**Electric Ireland Response:**  
**Capacity Remuneration Mechanism Detailed Design**  
*Capacity Requirement and De-Rating Consultation Paper*

***SEM-16-051***

**5<sup>th</sup> October 2016**

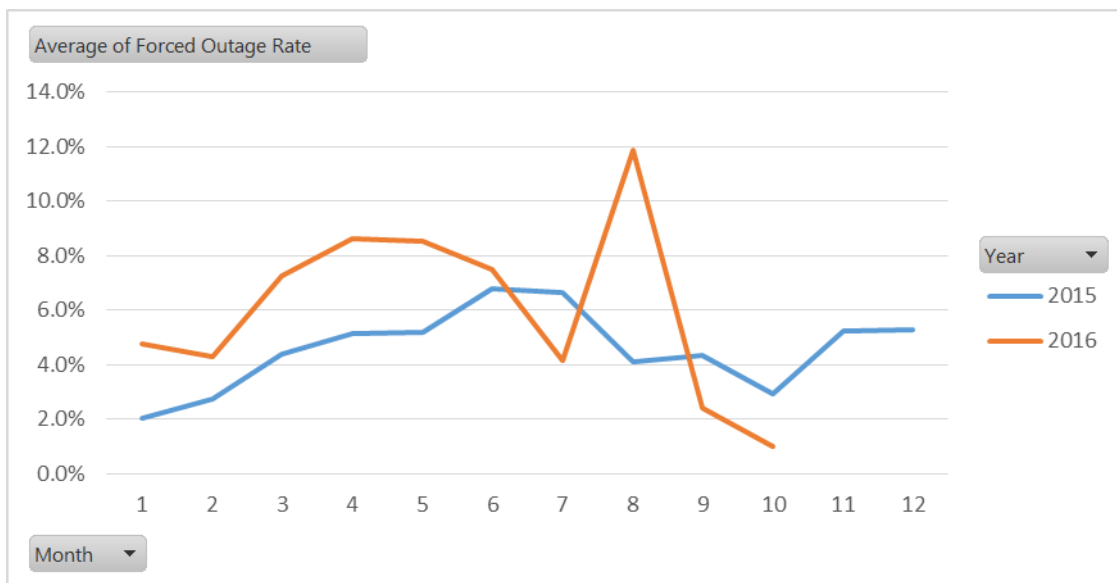
Consequently, other than a forced outage of the DSU control centre (a very low likelihood), any forced outage of the consumer assets is likely only to be partial. This is reflected in the operation of EI's DSU where at the day-ahead stage the availability of the DSU may be redeclared down but not to zero to reflect advance knowledge of the unavailability of a customer assets. The chart below shows forced outage levels for EI's DSU for the period Jan 2015 to September 2016 inclusive.

It is clear from the chart that the forced outage level is almost always only partial and very rarely full. This strongly indicates that a two-state on / off model is inappropriate for DSUs. If all, or a large number, of the instances of within-day redeclarations within the historical data are treated as full forced outages, this would significantly exaggerate the forced outage rate and correspondingly underestimate the de-rating factor value. EI's calculation of the forced outage rate for its DSU is 6.1% compared to the group value of 24.7% - a large discrepancy!

EI's DSU has been registered since April 2014 and during the period from January 2015 to September 2016 there have been 3 occasions when dispatch instructions have been issued (either as a test or as a market requirement). The average forced outage rate over this period was 6.1%, calculated as a percentage reduction in capacity delivered from the prevailing redeclared available capacity for each half hour and then averaged for each month and across the whole period. The corresponding scheduled outage rate is 13.4%. The monthly average forced outage rates are shown in the chart below.

These forced outage statistics for EI's DSU are significantly less than the DSU-AGU forced outage rate input value of 24.7% used in the analysis which would translate into to a much higher value for the de-rating factor than indicated for the group (since forced outage rates rather than scheduled outage rates drive this). This is further support for the assertion of legitimate technical variation within the DSU-AGU group. EI's scheduled outage rate of 13.4% is higher than the group value of 4.5% used in the analysis but EI's combined value of 19.5% is significantly lower than the group value of 29.2% indicating either anomalies in the treatment of data or significant variation within the group.
